Informal document No. GRE-65-23-Rev.1  
(65th GRE, 28-31 March 2011,  
agenda item 5(f))

## **Comments to ECE/TRANS/WP.29/GRE/2011/29**

The text reproduced below was prepared by the expert from OICA to propose amendments to Regulation No. 23 on the basis of ECE/TRANS/WP.29/GRE/2011/29. The proposal introduces a new category “manoeuvring lamps” to the 01 series of amendments to Regulation Nos. 23 (Reversing lights). The modifications to the existing text of Regulation No. R 23 are marked in **bold** for new or ~~strike through~~ for deleted characters.

Figure 4

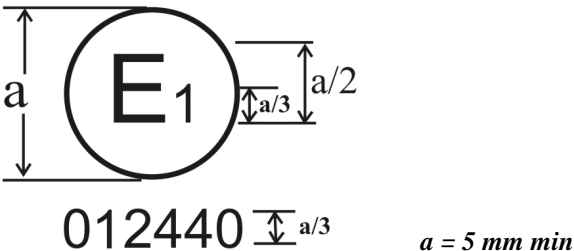
**Marking for an manoeuvring lamps**

The device bearing the approval mark shown above is a manoeuvring lamp approved in Germany (E1) pursuant to Regulation No. 23 under approval number 2440.

The approval number indicates that the approval was granted in accordance with the requirements of Regulation No. 23 in its original form as amended by the [01] series of amendments.
